# Wisconsin Department of Transportation

**Proposal #38: 8349-00-70**  
**Benoit – USH 2**  
**South Fish Creek Bridge B040019**  
**CTH F**  
**Bayfield County**

### Letting of November 13, 2018

This is Addendum No. 01, which provides for the following:

Addendum No. 01  
 ID 8349-00-70  
 Revised Sheet 40  
 October 17, 2018

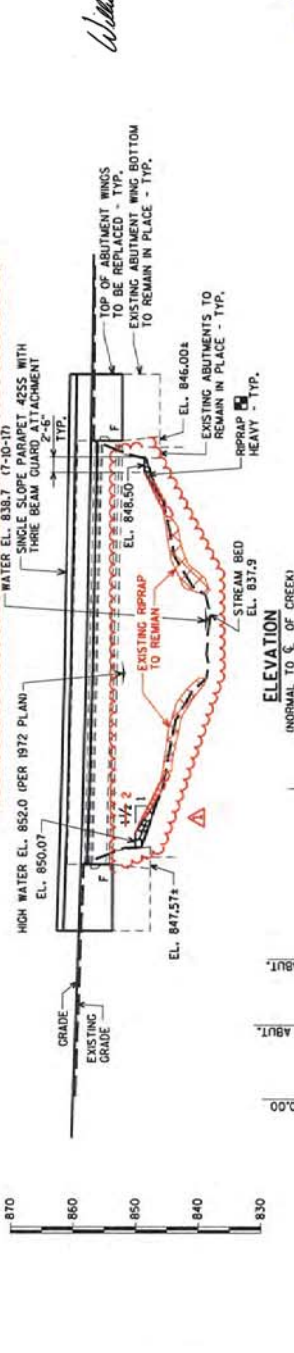
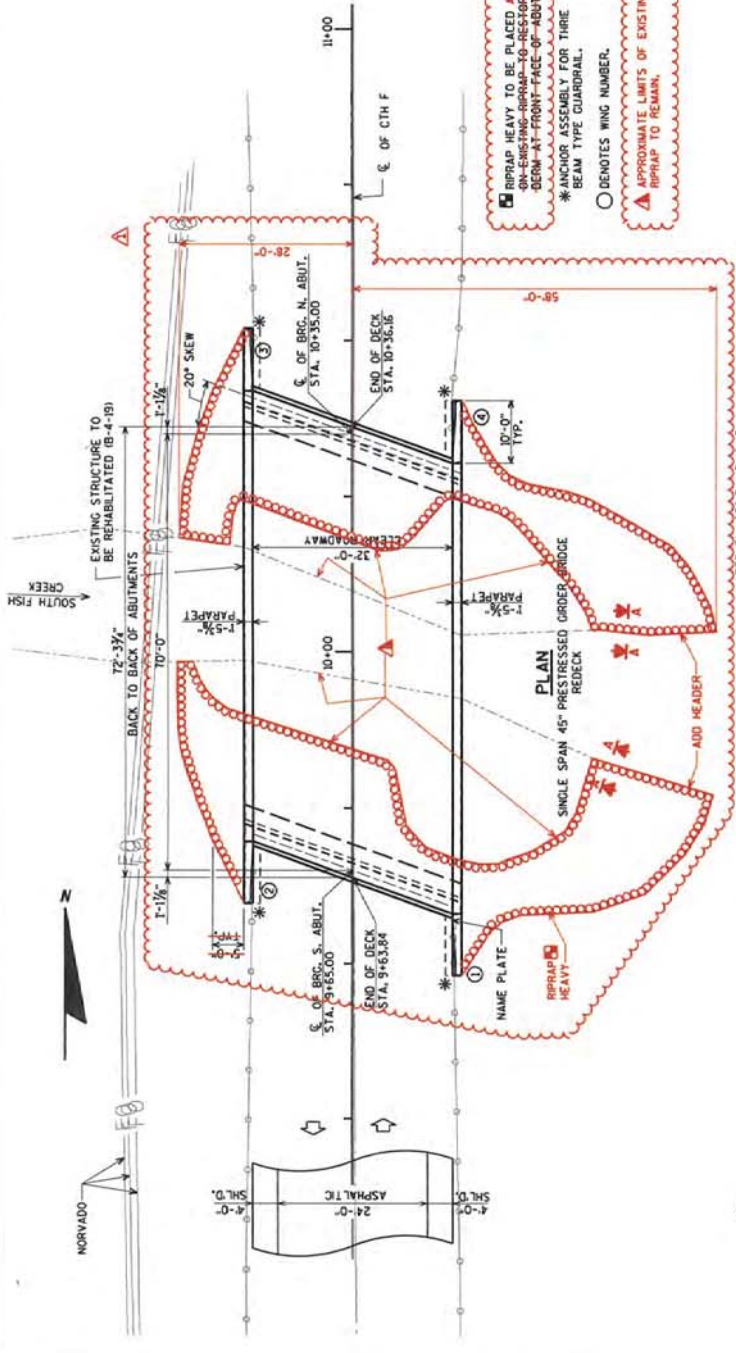
Revised Plan Sheets	
Plan Sheet	Plan Sheet Title (brief description of changes to sheet)
40	Structure B-4-19 General Plan: Revised Riprap Layout
41	Structure B-4-19 Typical Section, Quantities, and Notes: Revised Riprap Quantity

NO.	DATE	REVISION	BY
10/15/18		RIPRAP EXTENTS	ATRES

Addendum No. 01  
 ID 8349-00-70  
 Revised Sheet 41  
 October 17, 2018

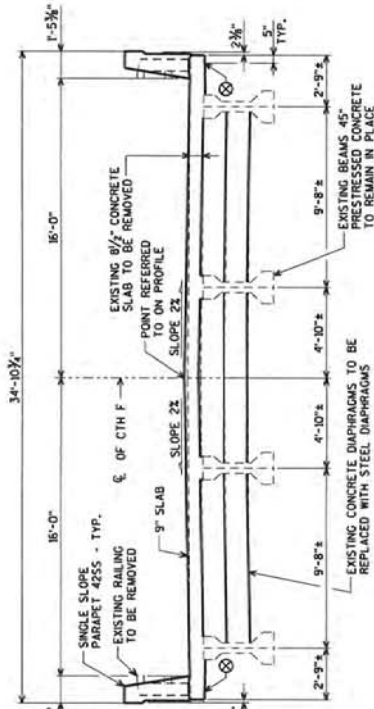
Revised Bid Item Quantities					
Bid Item	Item Description	Unit	Old Quantity	Revised Quantity	Proposal Total
606.0300	Riprap Heavy	CY	70	110	180

NO.	DATE	REVISION	BY
A	10/15/18	RIPRAP QUANTITY	AYRES
